DRAWING AMENDMENTS:

REMARKS

Appendix A

Figure 7

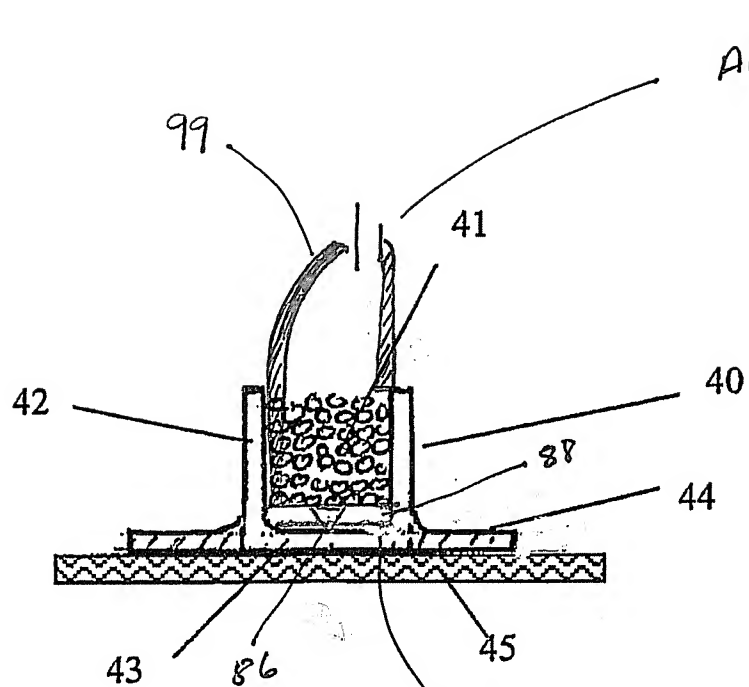
Figure 7 is amended to include the addition of a heater 99, a cutting means 86 retained in housing 88.

The examiner objected to the drawings because they do not show a cutting means or a heater. Amended Figure 7 – which shows the allegedly missing features – are added to the application in the Reply. The specification is amended above to include numeric designations for the amended Figure features. The Figure and specification amendments do not add new matter to the specification.

ADD HEATER 99

REMOVE BOTTOM layer of WINDINGS
 ADD HOUSING 88 INCLUDING
 RETAINED SHARPED EDGE 86

Figure 7 is amended to include a heater and cutting means. The specification is amended to add new Figure 7 designations. No new matter is added to the application by these amendments.
